[Docket No. FAA-2004-19960; Directorate Identifier 2004-CE-47-AD]

Airworthiness Directives; The New Piper Aircraft, Inc. PA-34 Series Airplanes

ACTION: Notice of proposed rulemaking (NPRM).

Figure 1

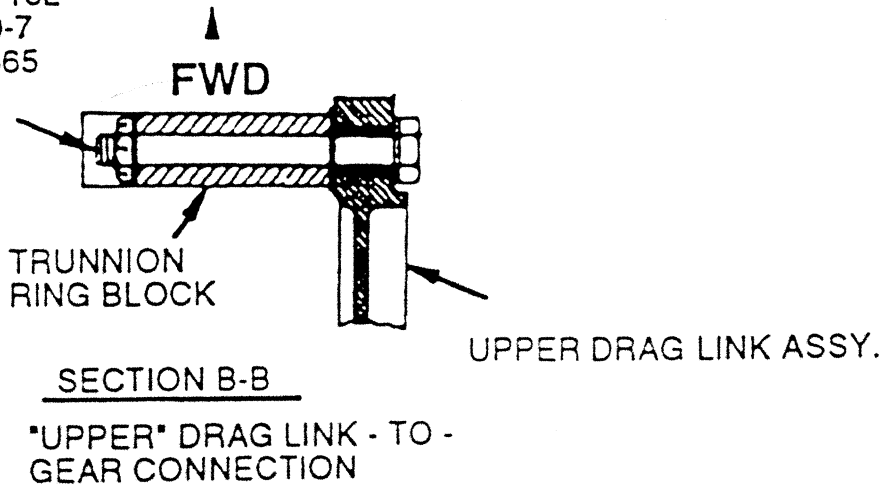
Actions	Compliance	Procedures
(1) Replace the bolt and stack up that connects the upper drag link to the nose gear trunion with new parts of the following: (i) Piper part number (P/N) 400 274 (AN7-35) bolt; (ii) Piper P/N 407 591 (AN960-716L) washer, as applicable; (iii) Piper P/N 407 568 (AN960-716); (iv) Piper P/N 404 396 (AN320-7) nut; and (v) Piper P/N 424 085 cotter pin.	Within the next 100 hours time-in-service (TIS) after January 28, 1994 (the effective date of AD 93-24-14), unless already done within the last 400 hours TIS before January 28, 1994 (compliance with AD 93-24-14). Repetitively replace thereafter at intervals not to exceed 500 hours TIS. Continue to repetitively replace until the actions in paragraph (e)(2) and (e)(3) of this AD begin.	Follow Figure 1 of this AD.
